April 18, 2024

Re: Bureau of Land Management Draft Programmatic Environmental Impact Statement for Utility-Scale Solar Energy Development (89 Fed. Reg. 3687)

Figure 7. BLM's Solar PEIS Alternatives 3 and 5 would make BLM land in the San Juan River watershed, New Mexico available for solar application.

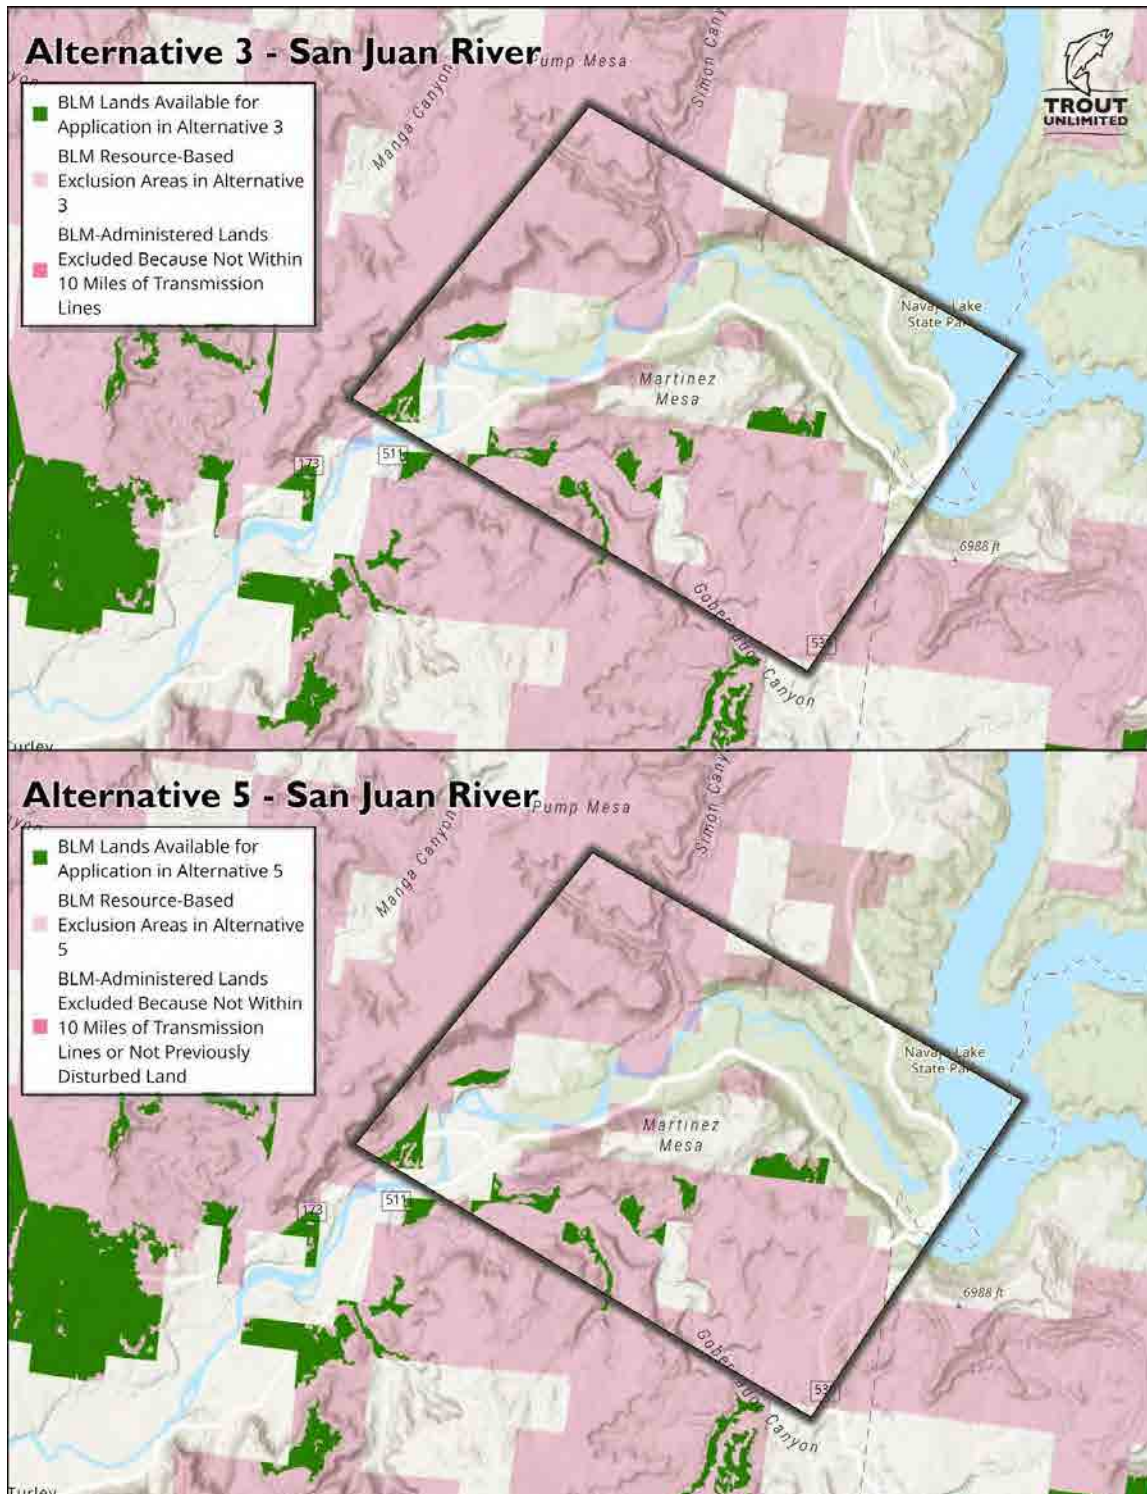
In New Mexico, approximately 3.75 miles of the San Juan River is designated Special Trout Waters, which is the most popular fishing area in New Mexico for wild rainbow and brown trout (Figure 7). This area is incorporated as a part of the Navajo Lake State Park, drawing over 1 million anglers annually, and it is an important part of the local recreation economy for San Juan County. Below the community of Navajo Dam (where Hwy 173 crosses the San Juan) wild brown and rainbow trout populations support several fishing lodges and guiding businesses. Looking at Alternatives 3 and 5, the BLM Cottonwood Campground could be impacted by potential utility-scale solar development, contradicting many of the conservation and recreation values already identified by BLM in their creation of overnight campgrounds, public fishing access, trails and other recreational uses for the San Juan River. We are concerned that the San Juan's Special Trout Waters, Navajo Lake State Park, and BLM Cottonwood Campground could be negatively impacted by fragmentation and degradation of trout habitat potentially caused by an increase of solar development in the region through watershed pollution, increased road development, industrial traffic, and transmission line impacts.

Figure 8. BLM's Solar PEIS Alternatives 3 and 5 would make BLM land in the Beaver River below Minersville, Utah available for solar application.

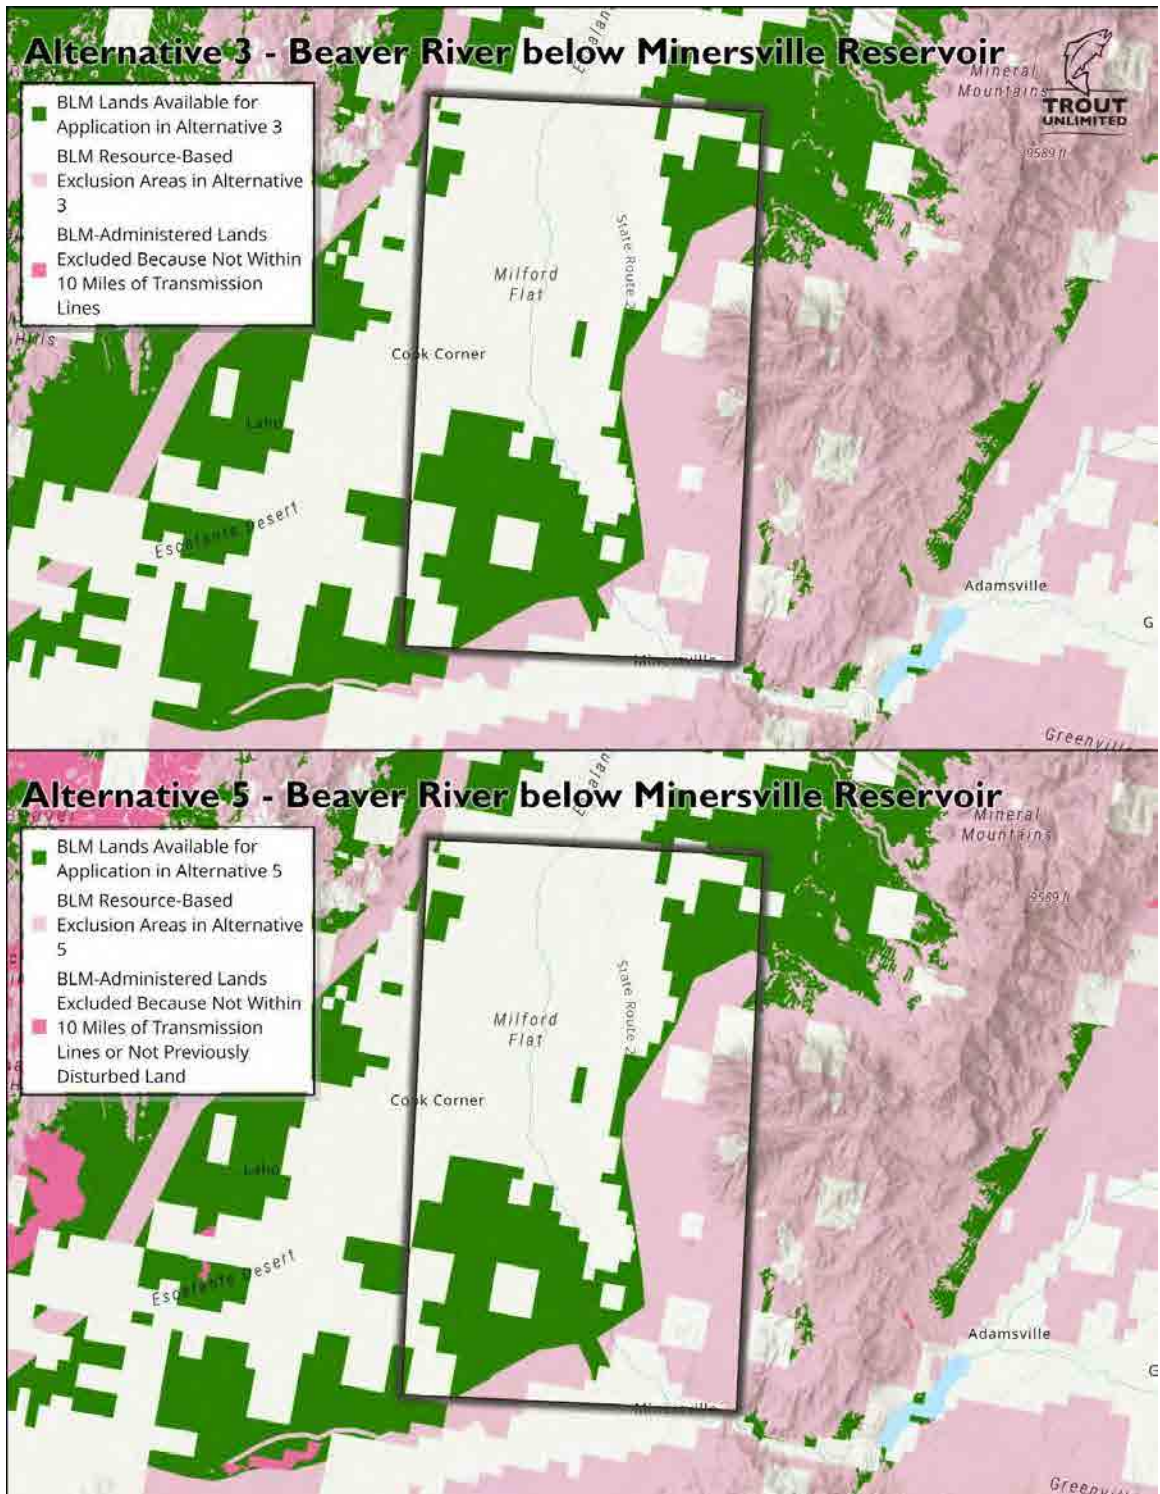
In Utah, the Beaver River (Figure 8) is an active restoration site managed by the Utah Division of Wildlife Resources. Trout Unlimited has worked with them as a partner to stabilize banks and bolster wild brown trout populations. This is a potential Utah Blue Ribbon Fishery. Blacks Canyon (Figure 9) is part of the Blue-Ribbon Fisheries network in the Upper East Fork of the Sevier River. Deer Creek (Figure 10) and North Creek (Figure 11) are also both tributaries to the Upper East Fork of the Sevier River that is a Blue-Ribbon Fishery in Utah. Any disturbance in those drainages may result in degradation and destabilization of banks leading to high sedimentation rates in spawning areas for wild and native fishes in those areas.
